PURPOSE: To communicate two upcoming changes to the I-Series Plus Combi and Heat-Only Installation and Operation Manuals.

- Applicable Product: Rinnai I-Series Plus Condensing Boilers (Combi and Heat-Only)
- Applicable Models:
 - **Combi Models:** IP060160C, IP090099C, IP090160C, IP090199C, IP120199C, IP150199C, IP175199C, IP199199C
 - **Heat-Only Models:** IP060S, IP090S, IP120S, IP150S, IP175S, IP199S

Figure 1

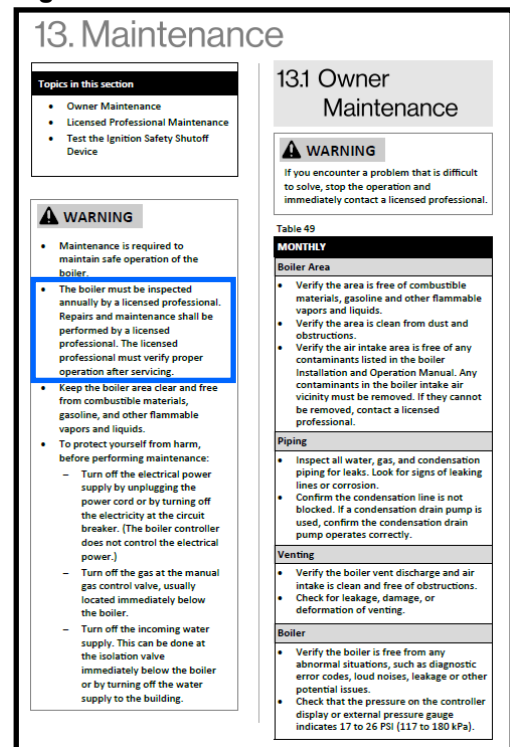
The first update to the I-Series Plus Boiler Combi and Heat-Only Installation and Operation Manual applies to section “13. Maintenance” (Figure 1).

In the second bullet point in the “Warning” section, the terminology “must be” and “must verify” are changing to “is recommended to.” For example:

Current Statement:

"The boiler **must be** inspected annually by a licensed professional. Repairs and maintenance shall be performed by a licensed professional. The licensed professional **must verify** proper operation after servicing."

Revised Statement:

"The boiler **is recommended to** be inspected annually by a licensed professional. Repairs and maintenance shall be performed by a licensed professional. The licensed professional **is recommended to** verify proper operation after servicing."

Figure 2

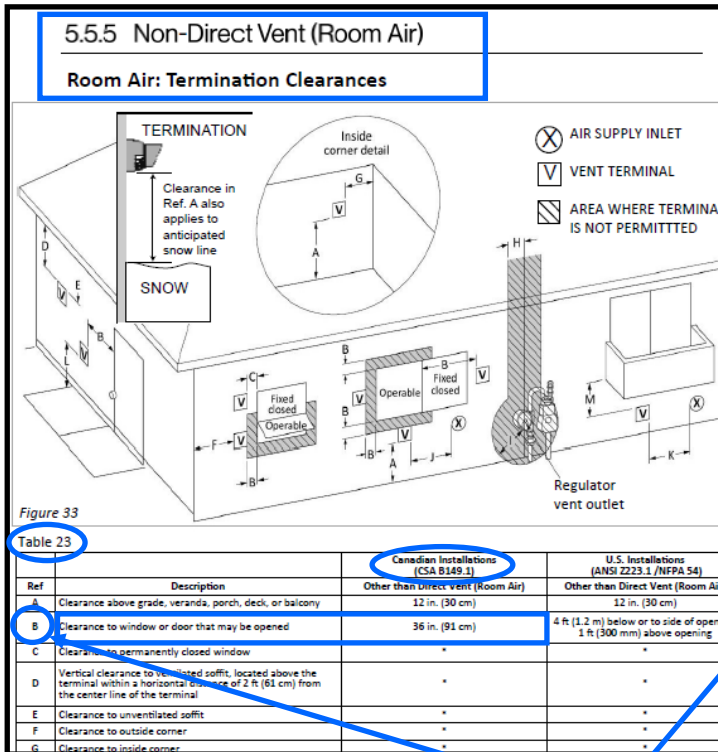
- **Section in Manual: 5.5.5 Non-Direct Vent (Room Air) Termination Clearances**
 - Table 23, Reference B (Clearance to window or door that may be opened) (Figure 2).
- **Section in Manual: 5.5.2 Direct Vent (Concentric and Twin Pipe) Termination Clearances**
 - Table 15, Reference B (Clearance to window or door that may be opened) (Figure 3).

In both sections, Reference B for Canadian installations is being modified to reflect the new clearances as shown in the table below.

Ref B (Canadian Installations) REVISED Clearances:

Ref	Description	Canadian Installations (CSA B149.1)
B	Clearance to window or door that may be opened	<ul style="list-style-type: none"> • 6 in. (15 cm) for appliances ≤ 10,000 Btu/hr • 12 in. (30 cm) for appliances > 10,000 Btu/hr and ≤ 100,000 Btu/hr • 36 in. (91 cm) for appliances > 100,000 Btu/hr

The above clearance adjustments are required to ensure compliance with the CSA B149.1 standard, as well as ensure a safe and proper installation.
